Service Bulletin No: 27-012

Modification No: EC-17-0264

**FLIGHT CONTROLS - SPOILERS  
LUBRICATION OF THE SPOILER CONTROL ROD-TO-SPOILER ACTUATOR CONNECTION-BOLT AND  
INSTALLATION WITH AXIAL PLAY****1. Planning Information****A. Effectivity**

Removal, Lubrication and Re-installation of the Rod End Bolts With Axial Play  
Figure 1

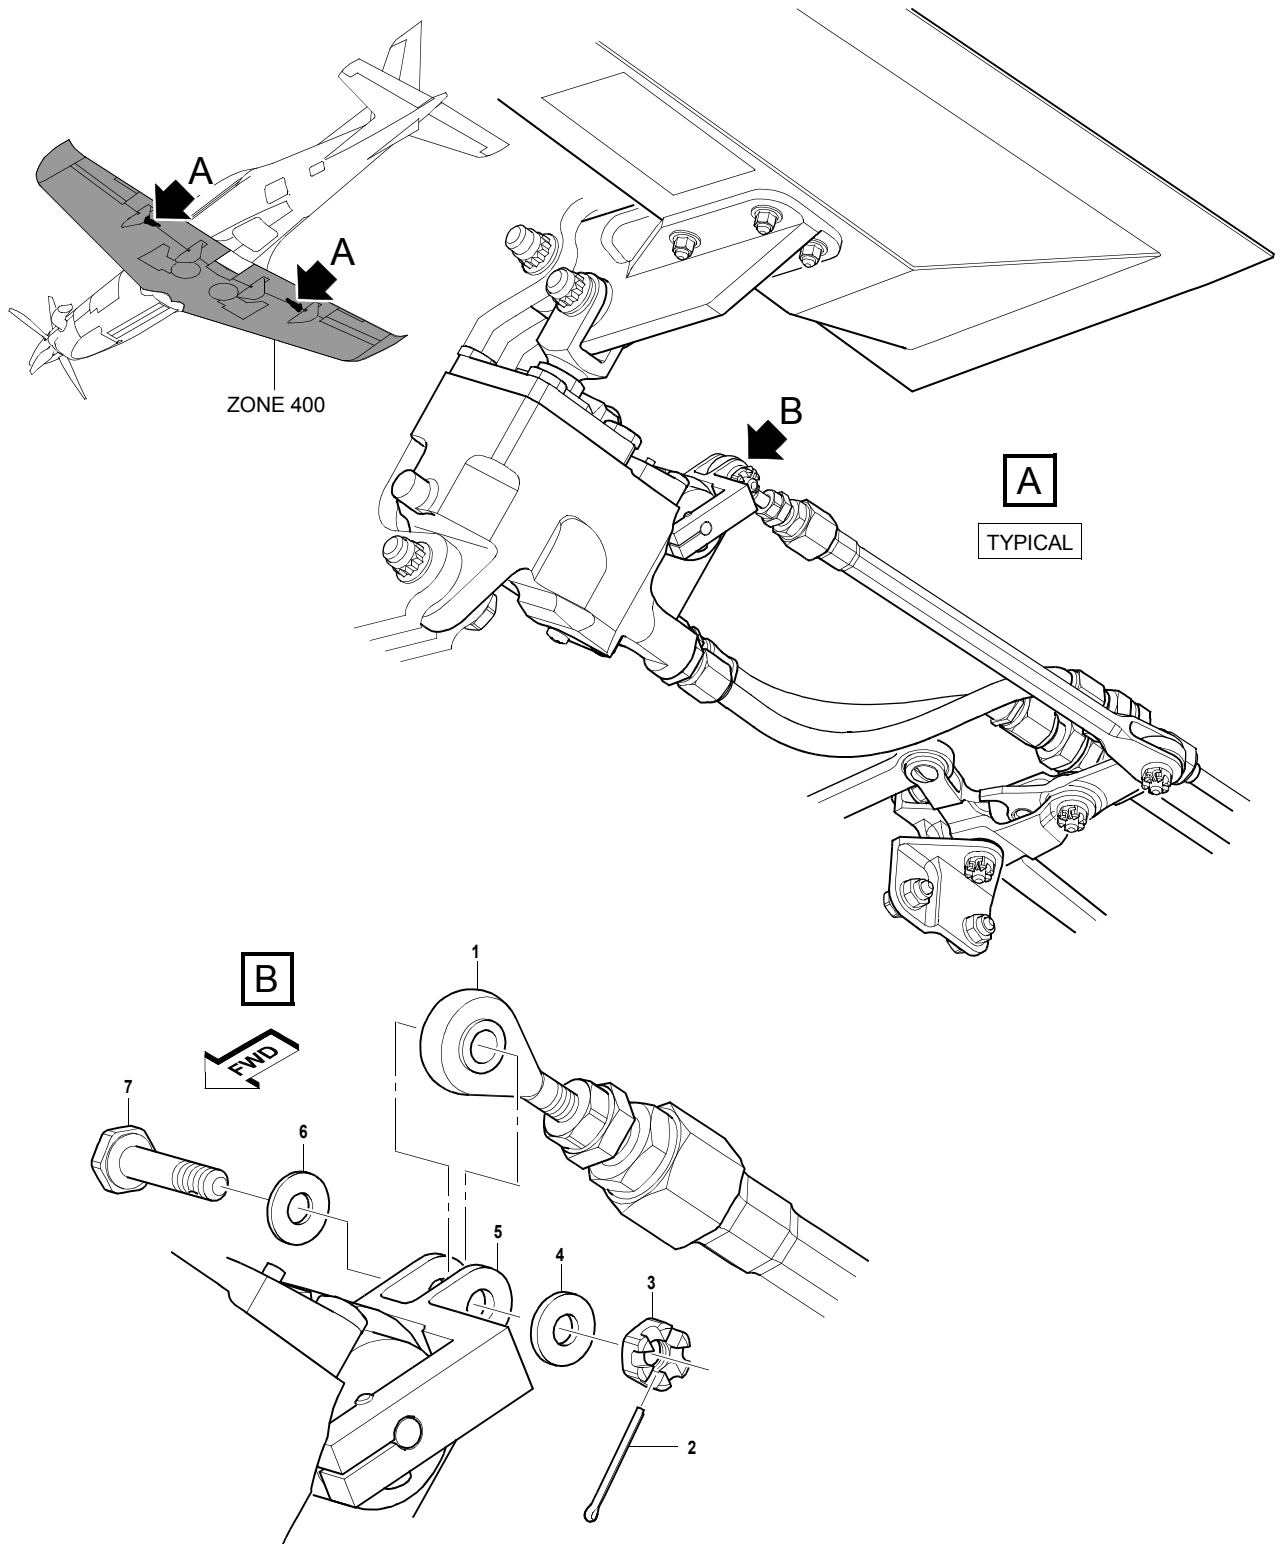
On some aircraft installed with spoiler control rod end P/N 944.61.12.001, spoilers have been found slightly deployed when the pilot had selected the aileron to the neutral position.

The following procedures are introduced to the spoiler control rod at the spoiler actuator connection-bolts:

- The actuator rod bolts are removed
- The actuator rod bolts are lubricated and re-installed with an axial play tolerance and no requirement to torque tighten.

**B. Modification (Ref. Fig. 1)**

- (1) Remove and discard the cotter pin (2).
- (2) Remove the nut (3), the washer (4), the washer (6) and the bolt (7) and disconnect the spoiler control rod (1) from the spoiler actuator lever (5).
- (3) Clean the bolt (7), the washers (4) and (6) and the nut (3) with the absorbent paper (Material No. P02-031) made moist with the solvent (Material No. P01-010).

- (7) Apply a layer of the grease (Material No. P04-028) to the plain part of the bolt (7).
- (8) Install the bolt (7), the washer (4), the washer (6) and the nut (3).

- (9) Tighten the nut (3) until there is 0.4 mm (0.016 in.) axial play on the bolt (7).
- (10) If necessary, continue to tighten the nut (3) until the hole for the new cotter pin (2) aligns with the next cut-out in the nut (3).

- (11) Make sure the axial play is more than 0.1 mm (0.004 in.).
- (12) Safety the nut (3) with the new cotter pin (2) (P/N 940.17.02.317).
- (13) Do Steps 3.B.(1) thru (12) for the other spoiler.
